# CHEM—NUCLEAR SYSTEMS INC.

September 30, 1982

Reference: Docket No. 71-6601  
NRC Letter to CNSI dated 10/14/81  
CNSI Letter to NRC dated 2/8/82

## RESPONSES TO 8-120 QUESTIONS

CNS 8-1206 Shipping Cask Drawing

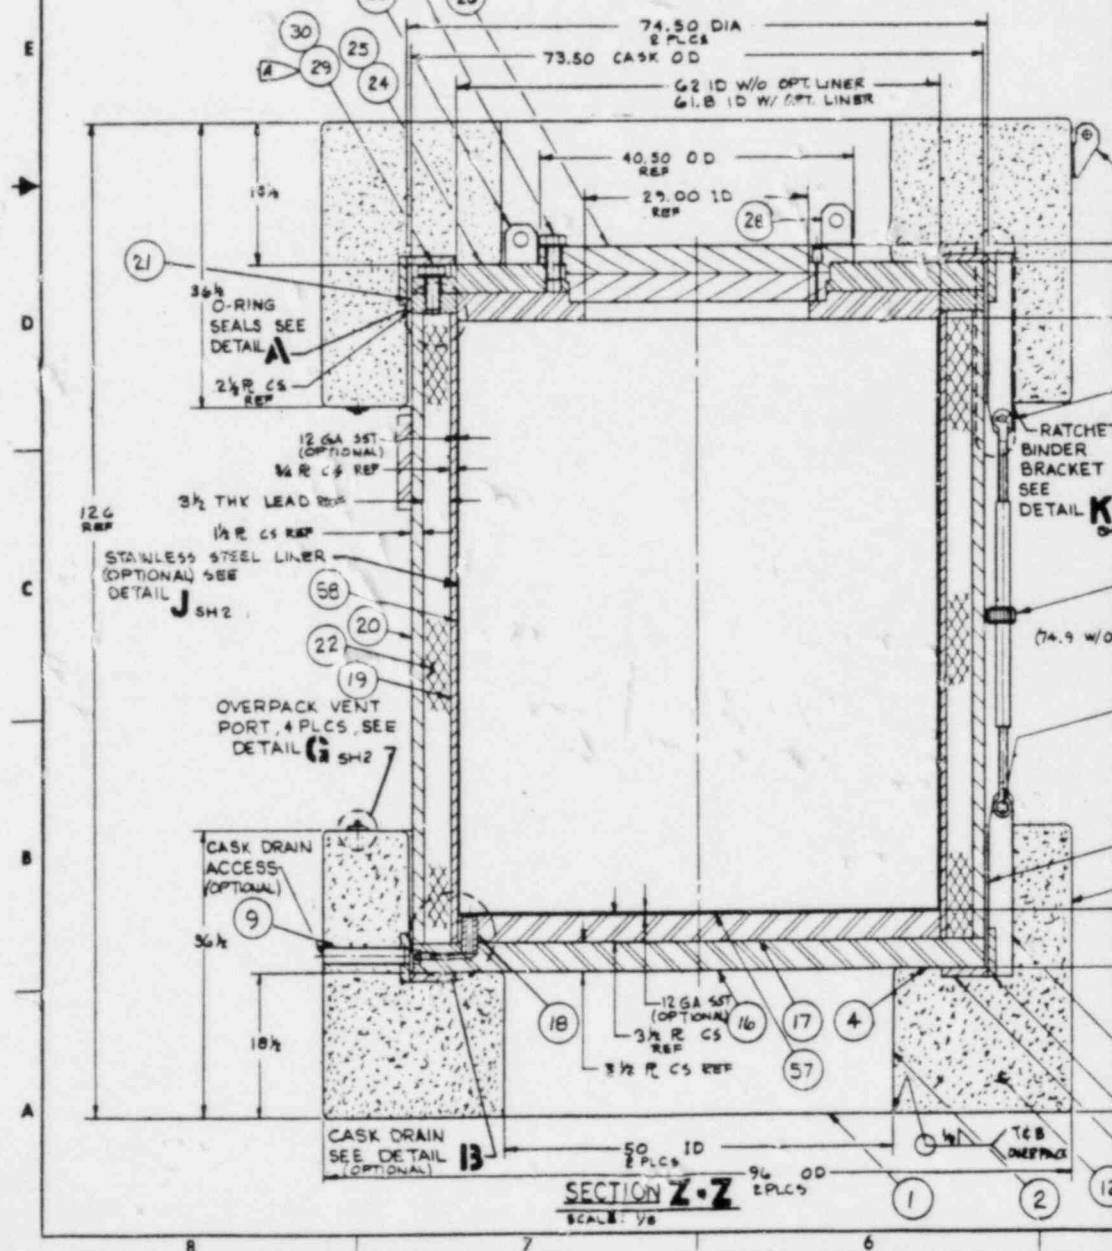
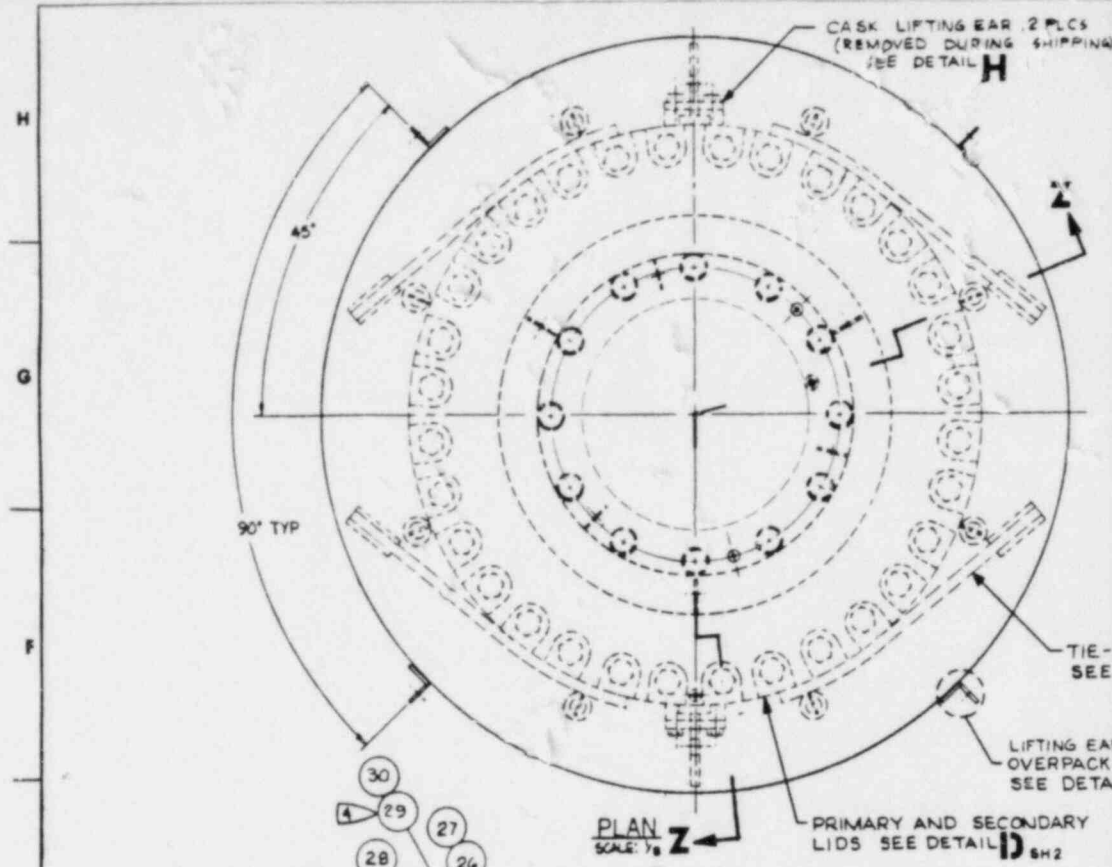
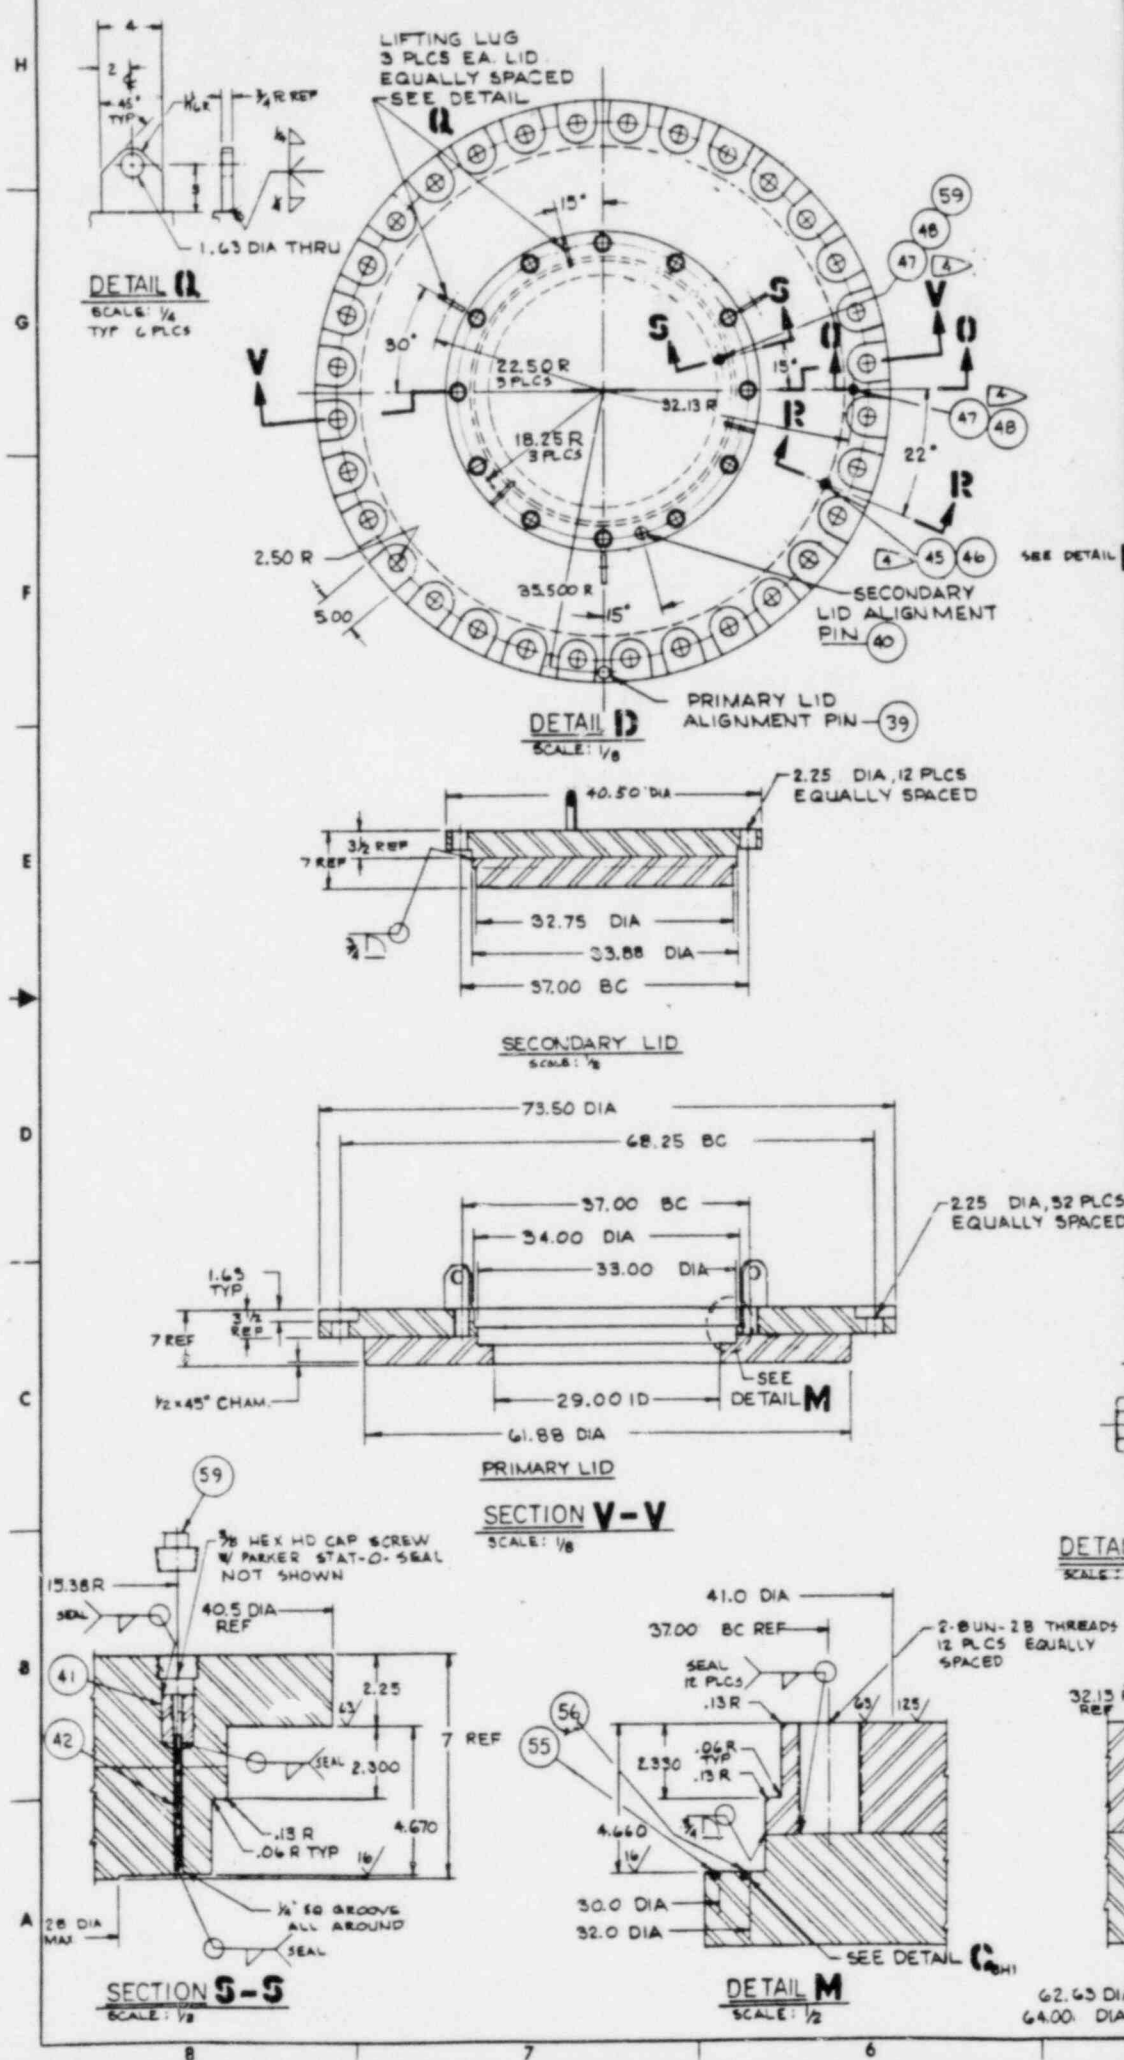
The package drawings should be revised to provide the following information:

Question No. 8-c

- c. The torque to which the cover plugs are tightened and the method or devices which provide a seal at these plugs.

Cover bolt torque is now included in the package drawings, Appendix 1.3, and in Section 4.0 of the revised SAR.

Drain plug sealing devices and seals are shown on the package drawings of the revised SAR, Appendix 1.3. These devices are discussed in Section 4.0 of the revised SAR.

Dimensions for the clearances around the cover bolts and for the lid-to-cask body radial clearance are now included in the package drawings, Appendix 1.3 of the revised SAR. The impact of these clearances on bolt loads is discussed in response to question 3-b, above.
